QUALITY ASSURANCE -- NON-CONFORMANCE REPORT

Report No: NCR-000562

Welding	Concrete	Other	
Welding	Curing	Procedural	Bridge No: 34-0006
Joint fit-up	Coating	Other	Component: Bikepath Cantilever Bracket-End Plates
Procedural	Procedural	Description:

Reference Description: ZPMC performed base metal repairs without the prior approval of the Engineer on End Plates at OBG Sub-Assembly Bay 5

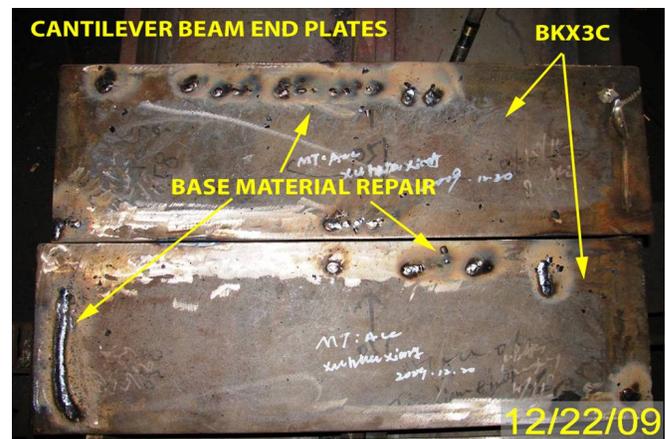
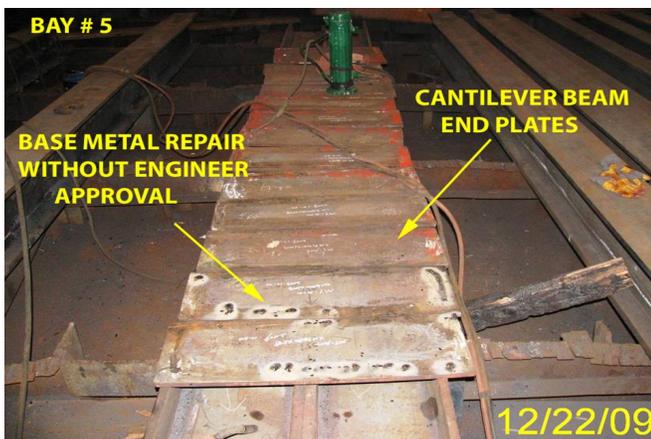
During random in-process visual inspection of the Orthotropic Box Girder (OBG) Bikepath Cantilever Bracket End Plates in fabrication Bay 5, the Caltrans Quality Assurance (QA) Inspector observed ZPMC personnel performing base metal repairs on two (2) End Plates without the Engineer's approval.

-The End Plates are identified as: BKX3C

-The Welding Procedure Specification (WPS) used was WPS-345-SMAW-1G (1F)-Repair.

Special Provision section 8-3.01: "The Engineer shall be notified immediately in writing when welding problems, deficiencies, base metal repairs, or any other type of repairs not submitted in the WQCP are discovered and also of the proposed repair procedures to correct them. For requests to perform repairs, the contractor shall include an engineering evaluation of the proposed repair."

For subsequent base metal repairs, notify the engineer prior to the start of work. Provide weld test information for this repair to the engineer. A response for the resolution of this issue is expected within 7 days.

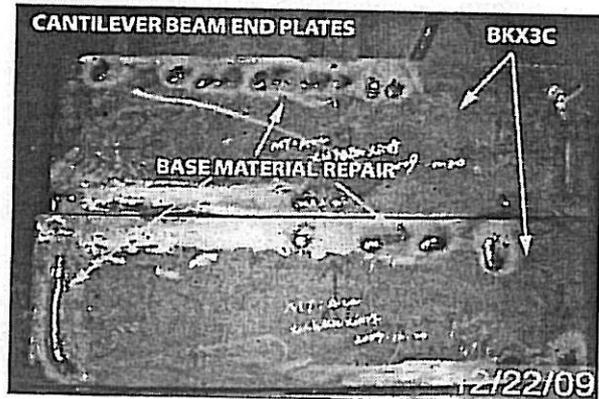
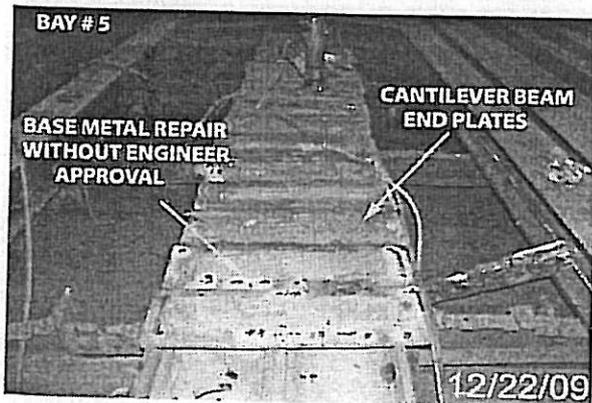
During random in-process visual inspection of the Orthotropic Box Girder (OBG) Bikepath Cantilever Bracket End Plates in fabrication Bay 5, the Caltrans Quality Assurance (QA) Inspector observed ZPMC personnel performing base metal repairs on two (2) End Plates without the Engineer's approval.

-The End Plates are identified as: BKX3C

-The Welding Procedure Specification (WPS) used was WPS-345-SMAW-1G (1F)-Repair.

Special Provision section 8-3.01: "The Engineer shall be notified immediately in writing when welding problems, deficiencies, base metal repairs, or any other type of repairs not submitted in the WQCP are discovered and also of the proposed repair procedures to correct them. For requests to perform repairs, the contractor shall include an engineering evaluation of the proposed repair."

For subsequent base metal repairs, notify the engineer prior to the start of work. Provide weld test information for this repair to the engineer. A response for the resolution of this issue is expected within 7 days.

焊缝返修位置示意图:
Draft of Welding Discontinuity:

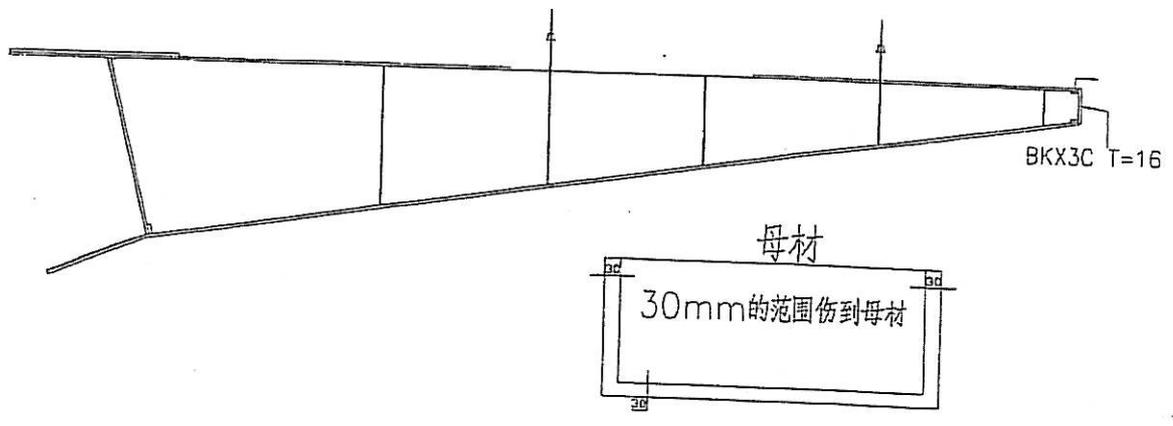
焊缝缺陷描述:
Description of Welding Discontinuity:
刘斌施工队制作的悬臂梁支架PP85-PP111(取奇数), 在去除前端的封板时伤到母材2-7mm不等。
Suspending bracket PP85-PP111(only including odd) fabricated by work team: Liu Bin, the base metal was gouged after removing seal plate, 2-7mm in depth.

Base metal gouged 30mm in area.

Worker operated error caused base metal gouged.

1. QC和CWI在整个修补过程中都应在场并指导以确保返修工作顺利进行;
 2. 按照焊接返修工艺规程 (WPS) 打磨缺陷区域;
 3. 准备一个正确的接头形式, 具体参见返修的WPS;
 4. 对该区域作100%MT检查, 确保缺陷全部去除;
 5. 根据批准的焊接返修工艺规程 (WPS) 进行预热及焊接;
 6. 将焊接区域打磨至与母材平齐;
 7. 根据图纸要求进行相应的NDT(VT、MT 和UT)检测;
-
1. QC and CWI should be present to witness the repair, direct and supervise all repair operations during this repair to ensure the repair is per the disposition requirements.
 2. Grind the repair area to a smooth finish according to the approved repair WPS.
 3. Prepare an right joint according to the approved WPS.
 4. Verify with MT and VT no defects remain in the repair area prior to welding;
 5. Preheat and weld according to the relevant WPS.
 6. Grind the weld flush with base metal after welding.
 7. Perform NDT inspection(VT、MT and UT) of the weld according to the working drawings.
